# BULLETIN # 28

**PROJECT:** Harrison Recreation & Community Center – PHASE 2  
Harrison, NY

**RE:** Delete Door SB2A

**ASK-29**

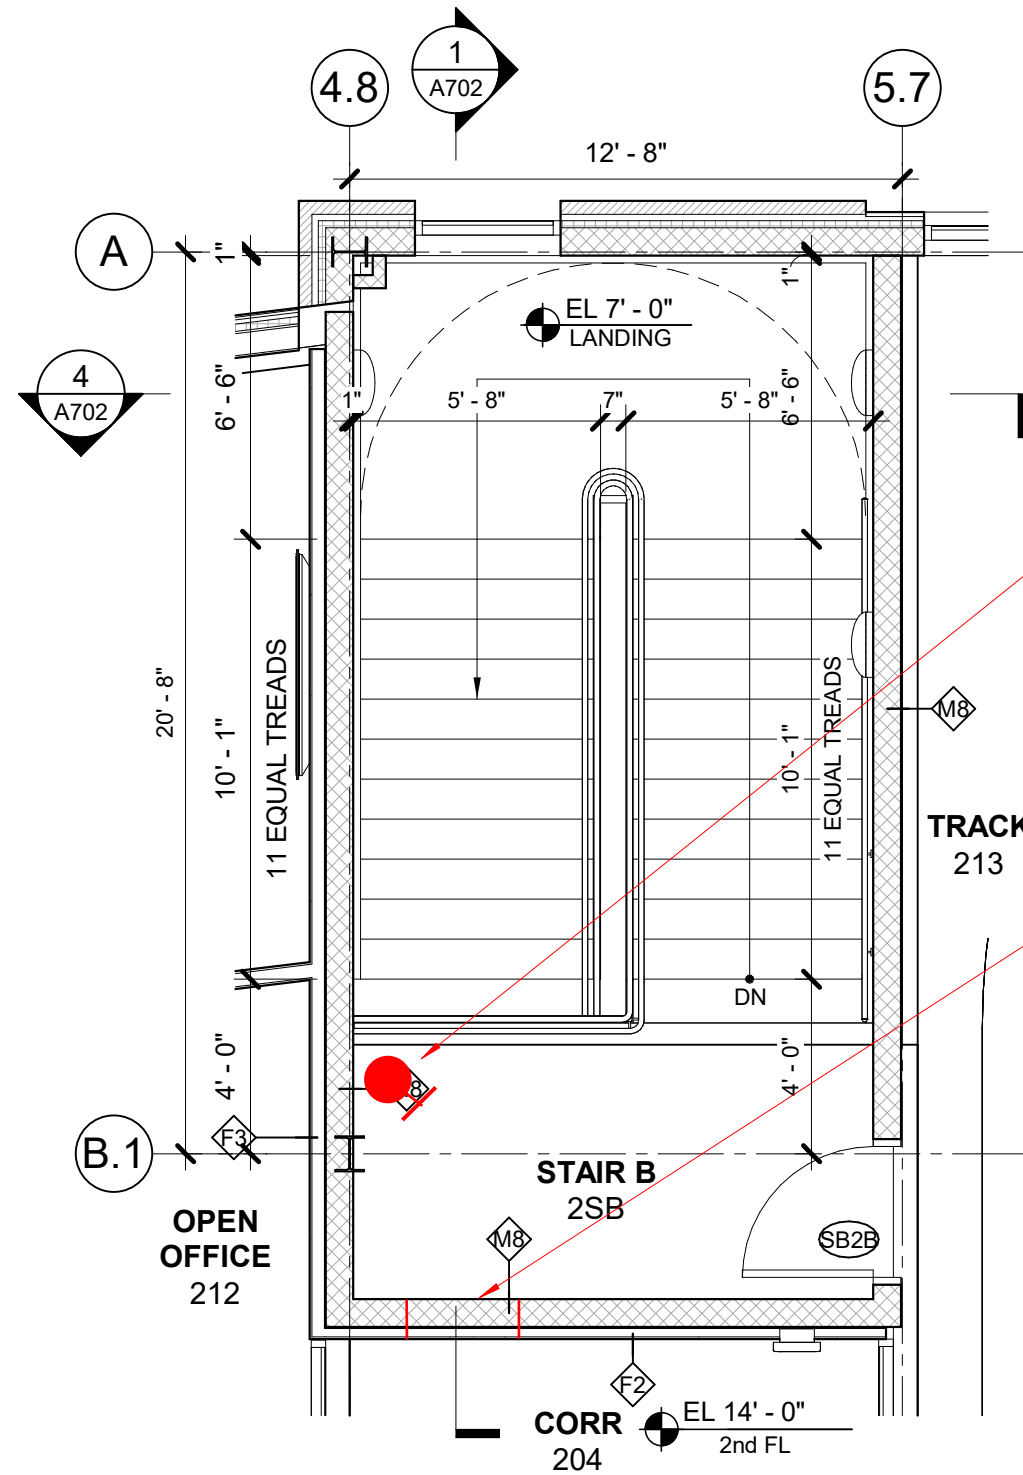
As discussed at the Project Meeting on 3/17/26 and previous walk throughs delete Door SB2A and infill that location with CMU and furring to match the adjacent wall construction, see attached ASK-29. Door is deleted to accommodate stand pipe valve clearances. The infill location is also used for the CUH at that level, see the response to RFI 217 Heaters in Stairs.

DELETE DOOR SB2A- INFILL CMU- COORD  
DEVICE INSTALLTION WITH MEP AND FP-  
SEE RFI 217 FOR CUH LOCATIONS
